**June 6, 2024**  
**I-195 Redevelopment District**  
**ADDENDUM NO. 001**

**Request for Proposals**  
**For**  
**Grounds Maintenance Services**

**C-100**

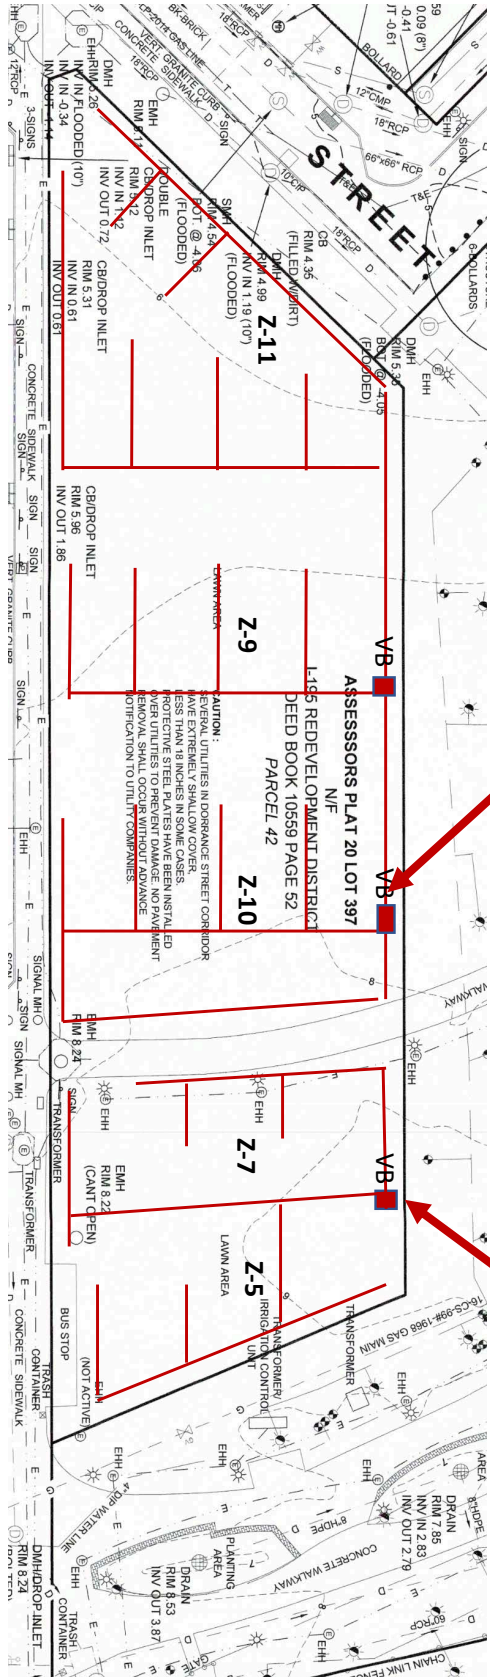
**Question #5: What type of irrigation system is in use? Are schematics available?**

**Answer #5:** The specifications from the park construction documents and an existing conditions plan showing location of irrigation system are provided in Attachment A.
